## NOTICE TO ALL BIDDERS

Re: **NURSING BUILDING MODERNIZATION – BUILDING 2100**

RFP No 20-21-20

Addendum # 01

A09.100

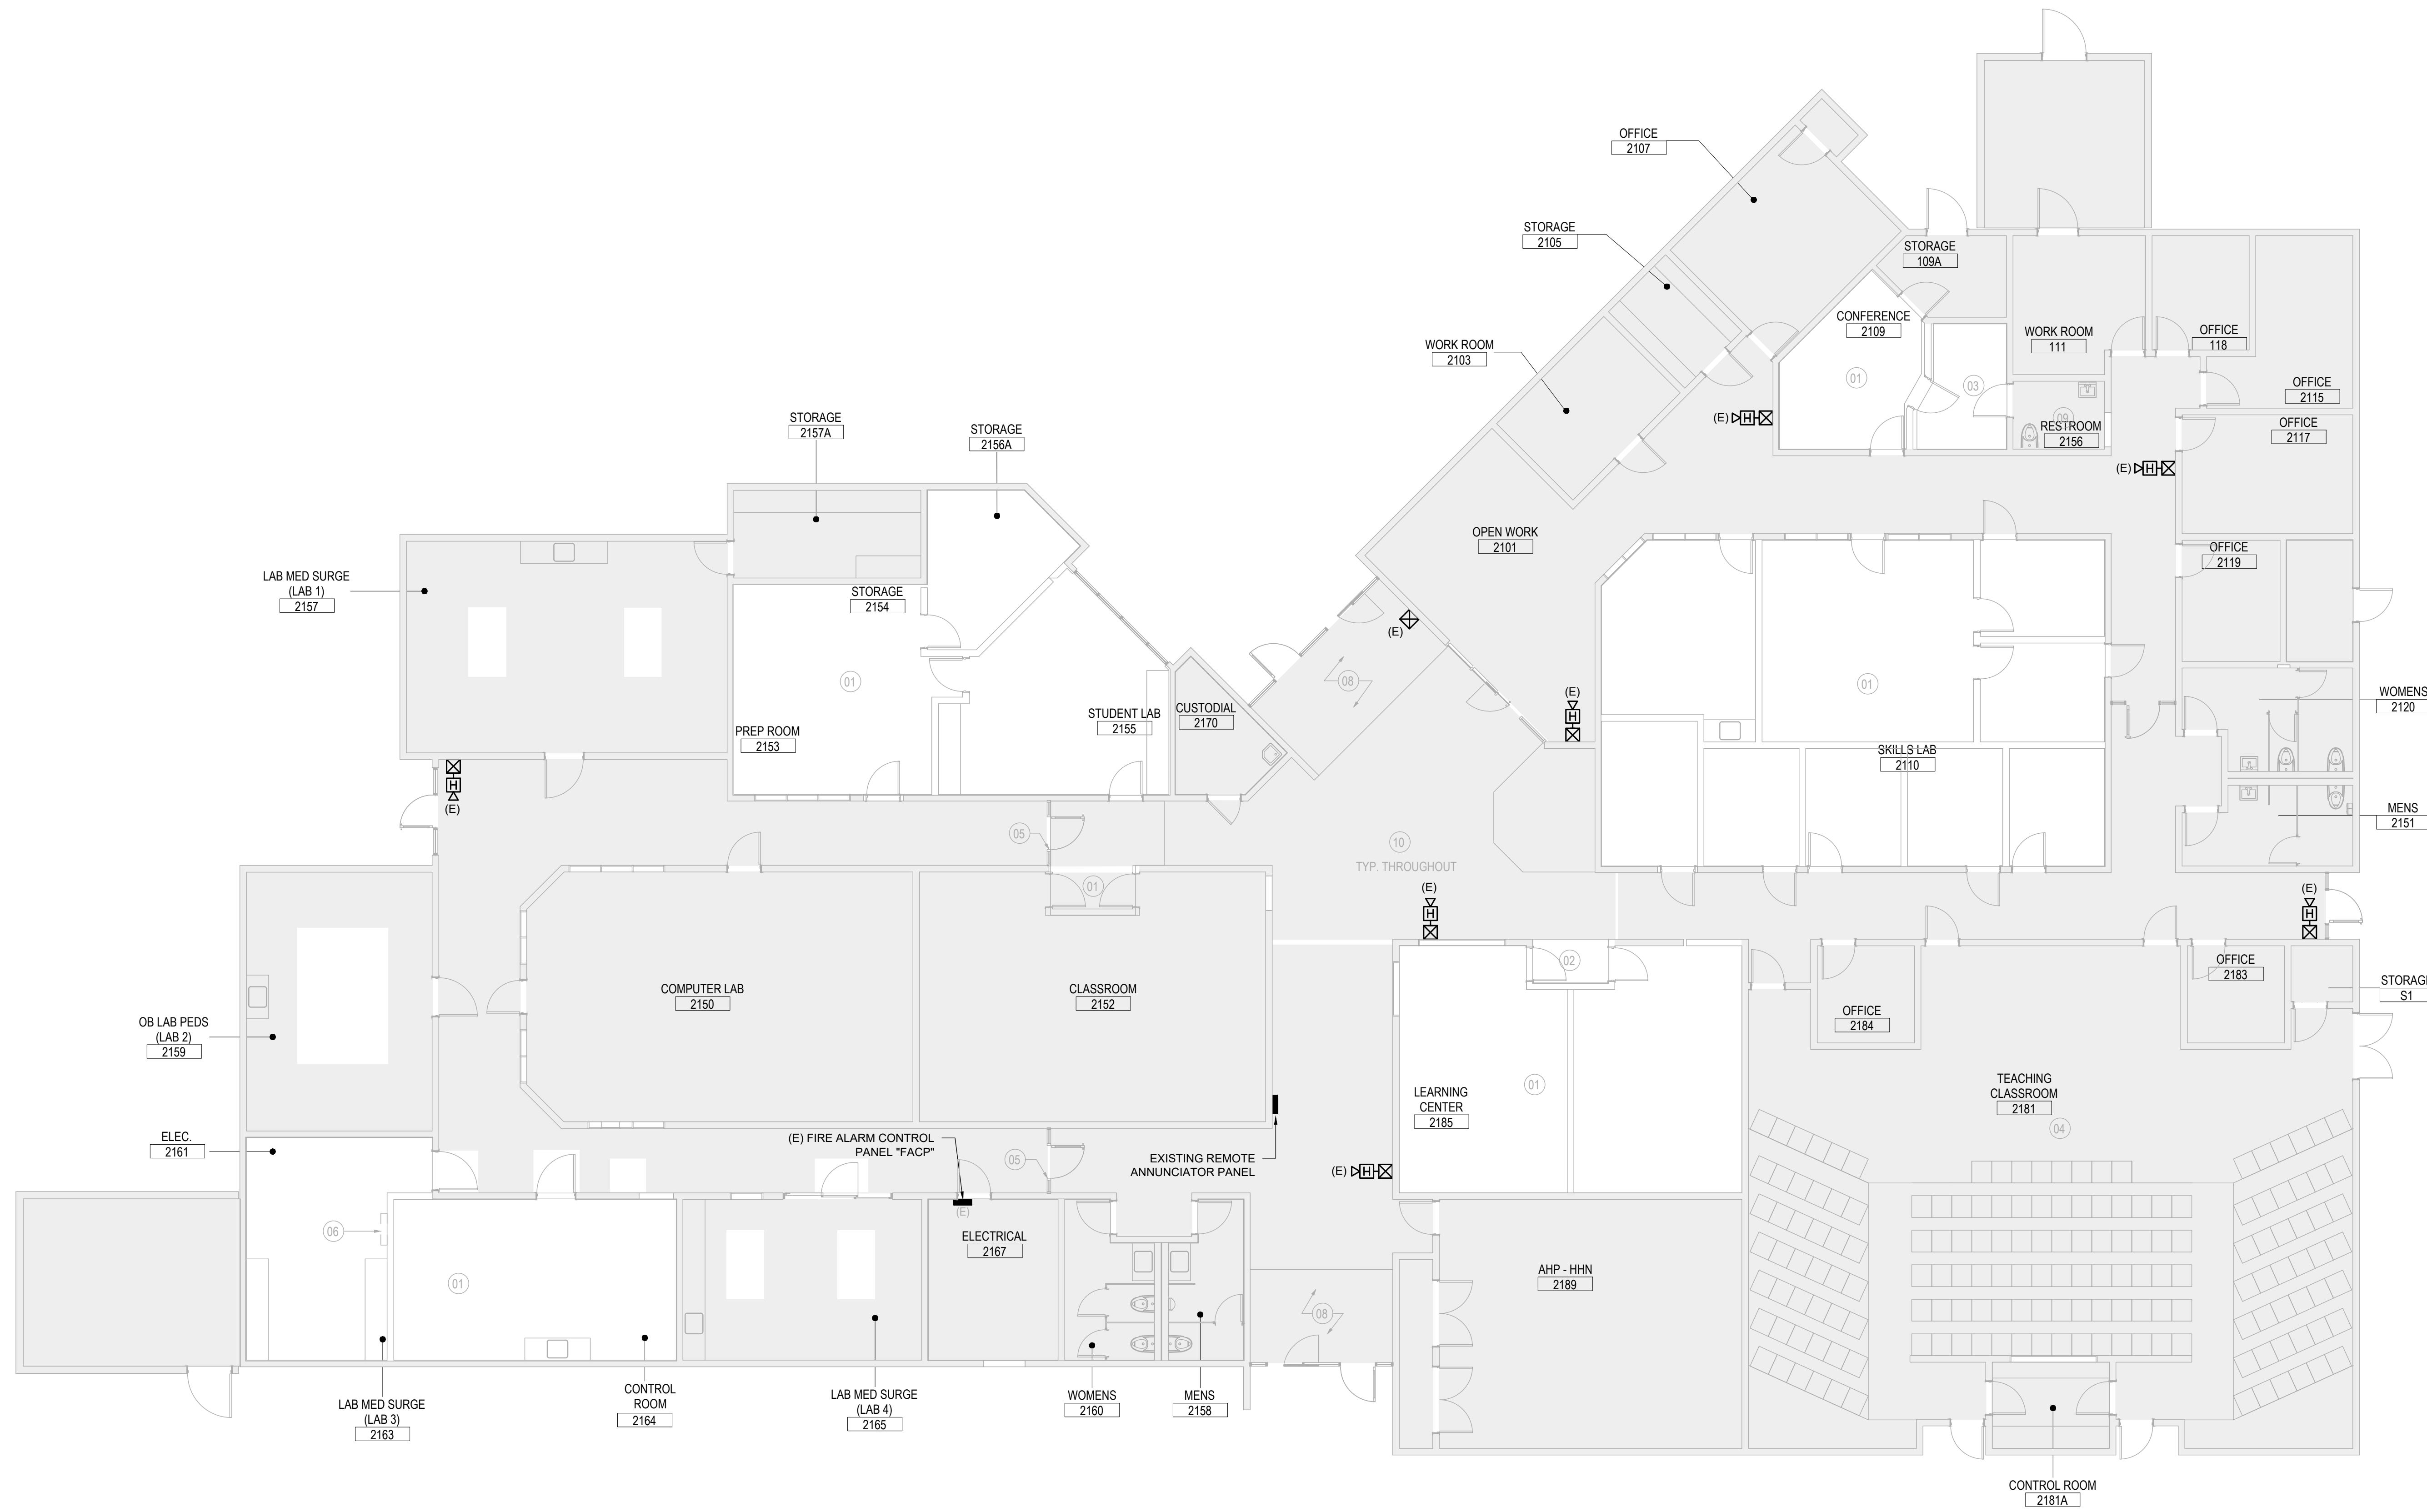
**Response:** Sheet G03.001 is Life Safety Plan. Exit signs and signage as indicated on plan will need to be provided
4. **Question:** On Sheet A09.100, fastener spacing for drywall and sheathing is listed at 2” in the field? Is that correct?

**Response:** Fastener spacing at field is 12” OC not 2”, see revised sheet A9.000 attached
5. **Question:** Is the tile make and/or color known for the bath tile patches if needed?

FASTENER SPACING FOR DRYWALL AND SHEATHING  
 8" O.C. AT PANEL EDGES  
 12" O.C. AT PANEL FIELD  
 TYPE 'S' SCREWS

**FA01.002**

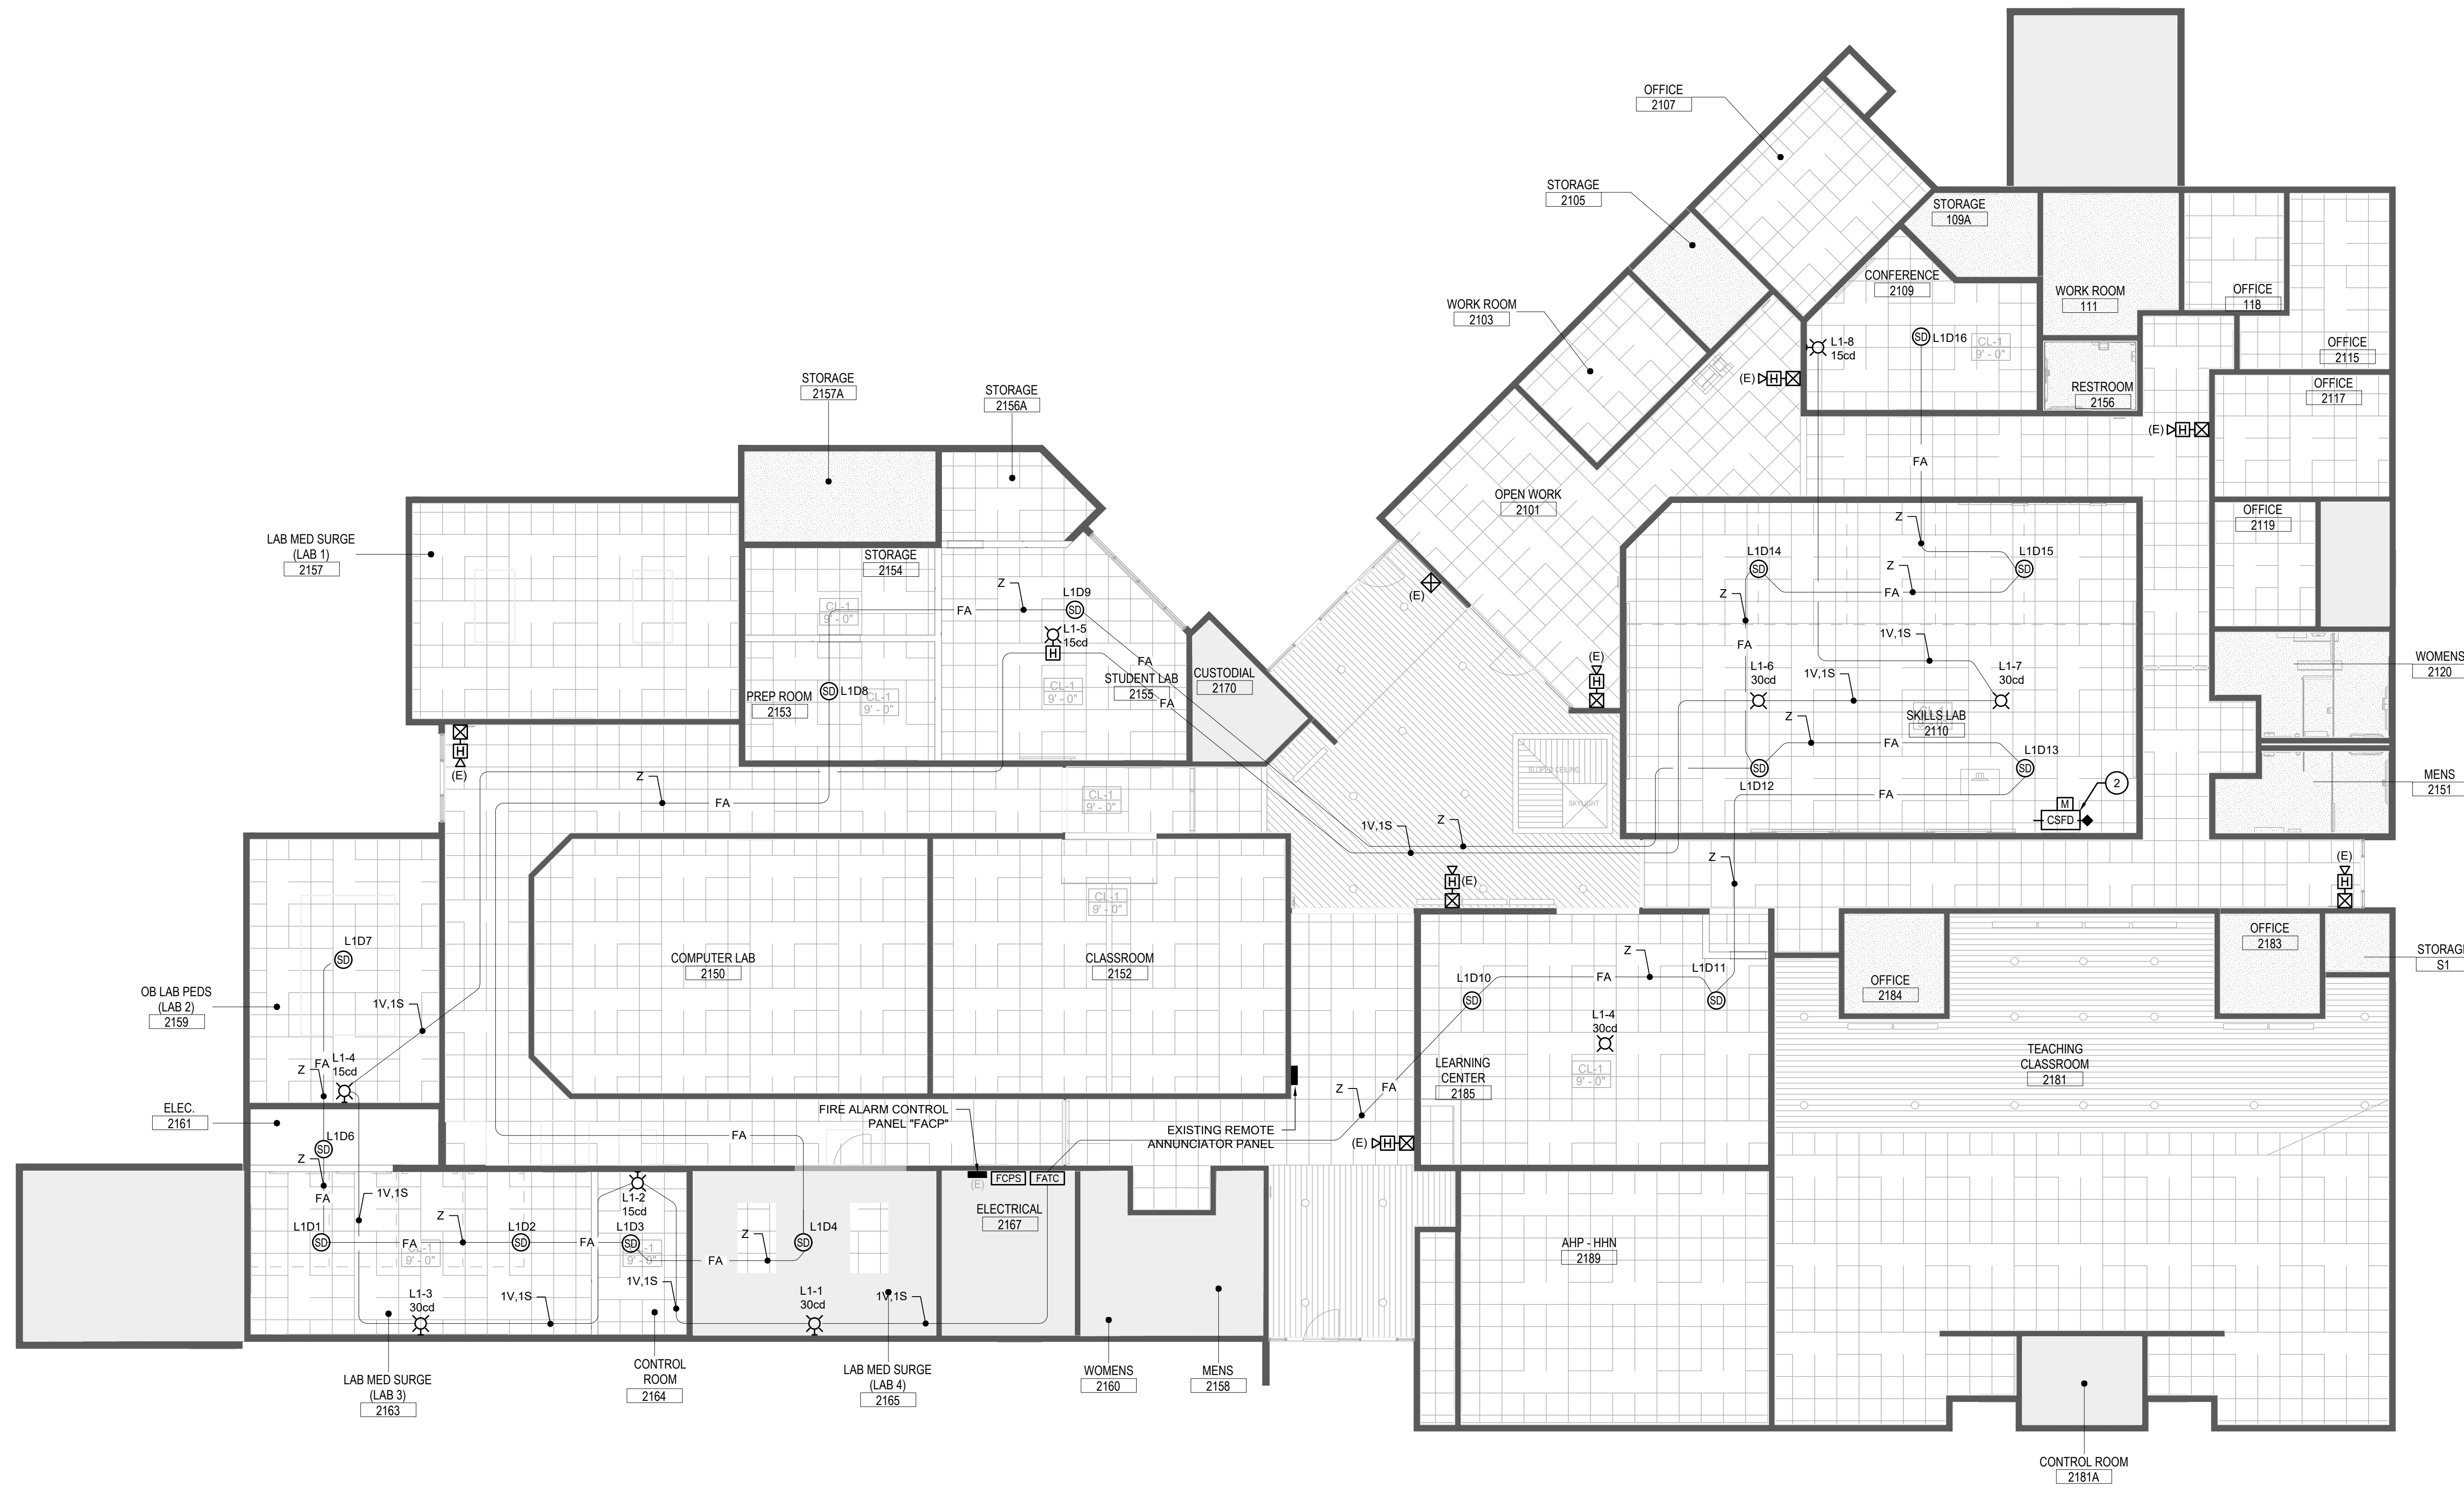
**Response:** The district currently uses the Symplex system for FA service. Johnson Controls is the proprietary provider.
16. See attached updated fire alarm drawings. The scope of fire alarm design includes a new fire alarm terminal cabinet and a new battery power supply located in the nursing building to feed new detector and notification devices. The new fire alarm terminal cabinet is going to be connected to the existing fire alarm control panel in electrical room 2167.
